**ADDENDUM NO. 1**

**May 29<sup>th</sup>, 2018**

**RE: Kelso Road & Burns Trail Sidewalks  
AHTD Job 061556  
Sherwood, Arkansas**

**FROM: GarNat Engineering, LLC  
2909 Military Road  
Benton, Arkansas 72015**

TYPICAL SECTION - SIDEWALK CROSSING DRIVEWAY  
N.T.S.

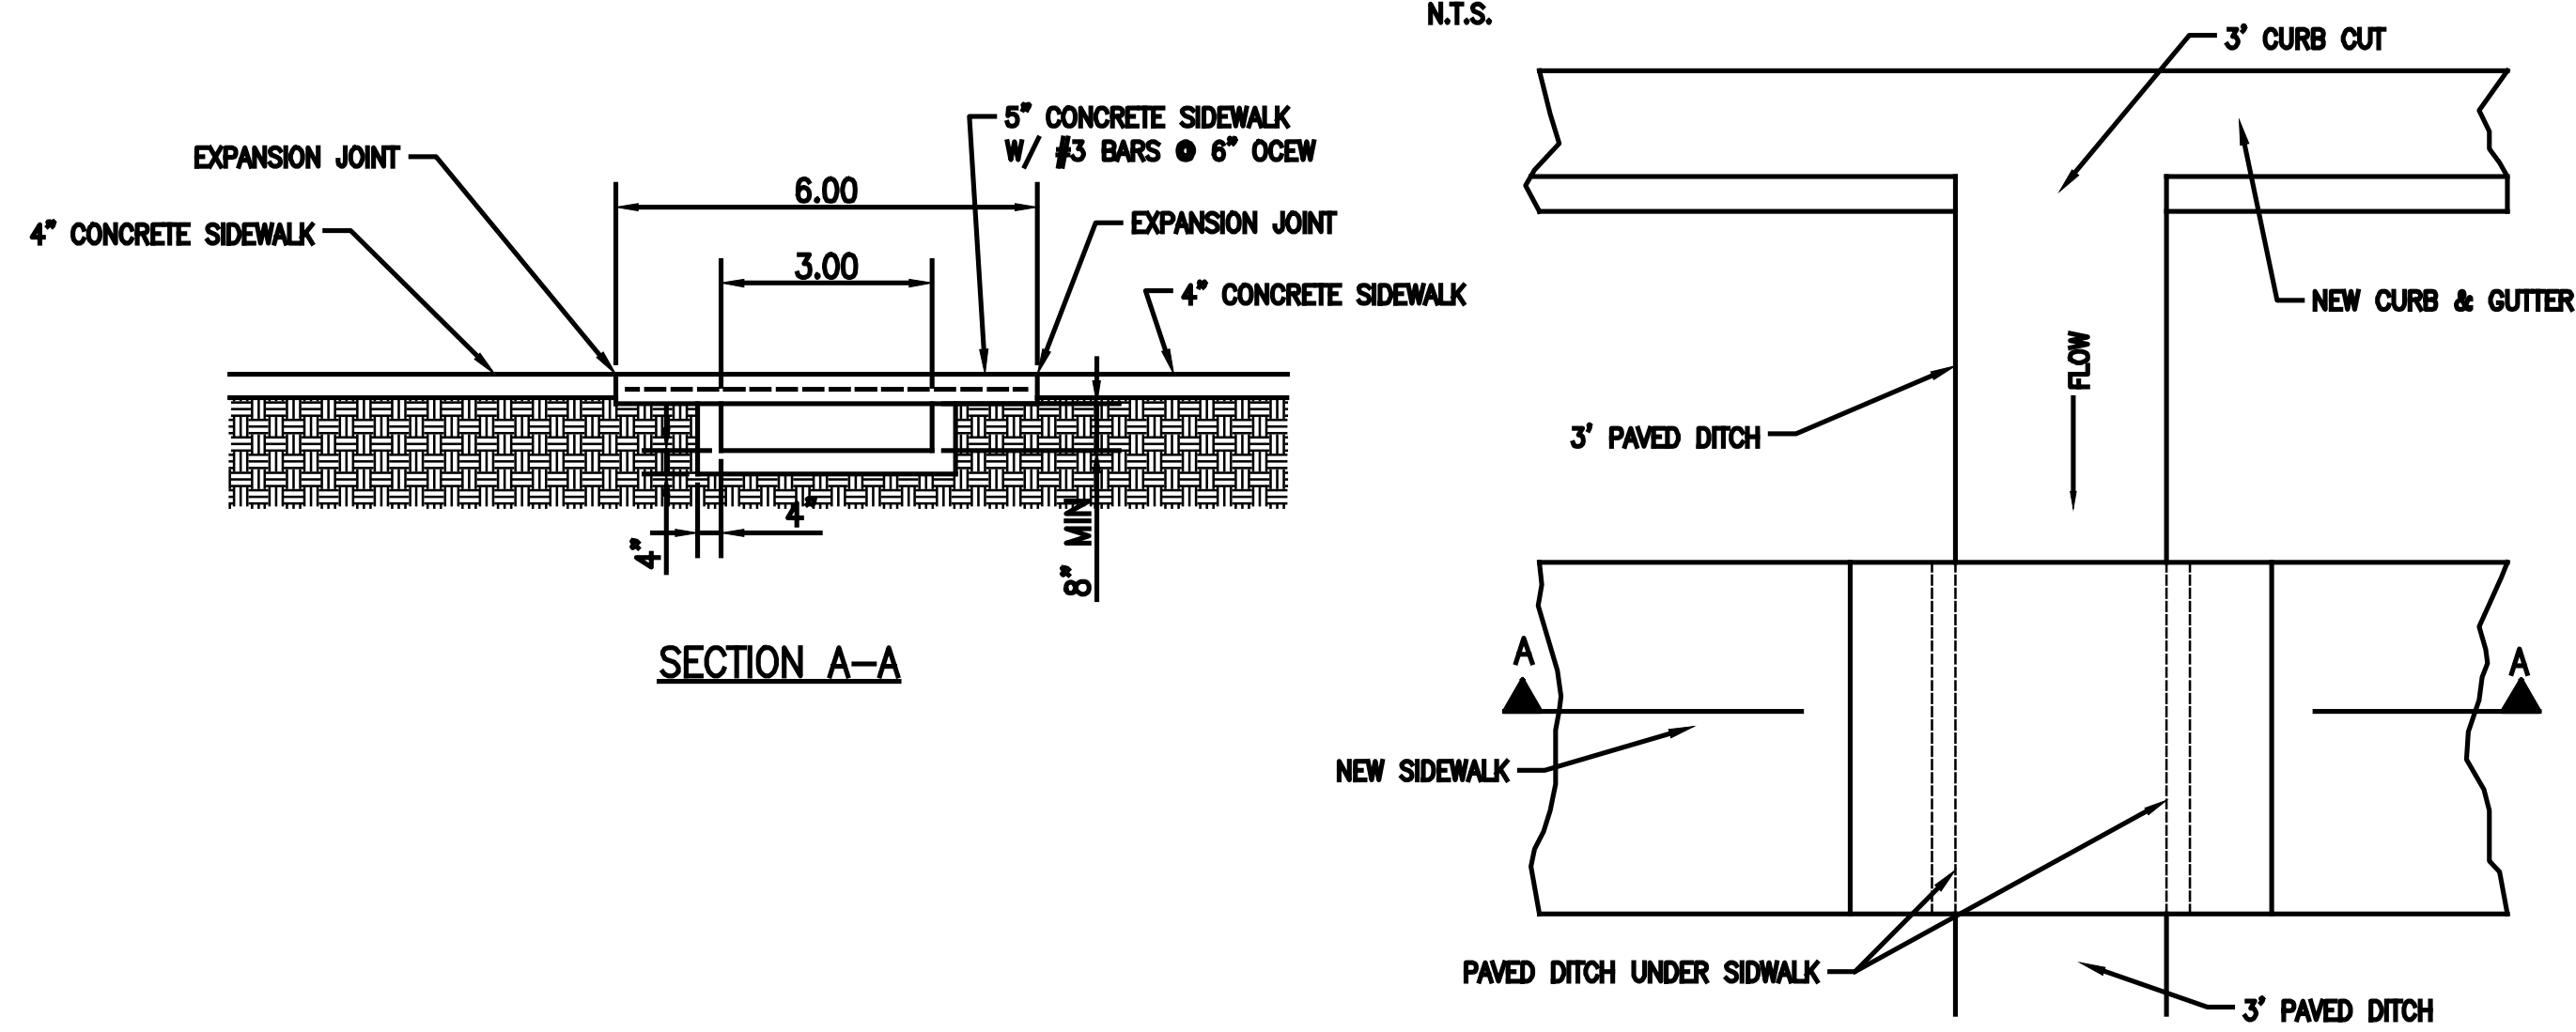
- C. Sheet 3 – Typical Sections
  - 1. Delete sheet and replace with enclosed document. Added locations for solid sodding on typical section.
- D. Sheet 6 – Summary of Quantities
  - 1. Delete sheet and replace with enclosed document.

BY	REVISION	DATE
KDV	#1 - ADDED SOD	5/29/18
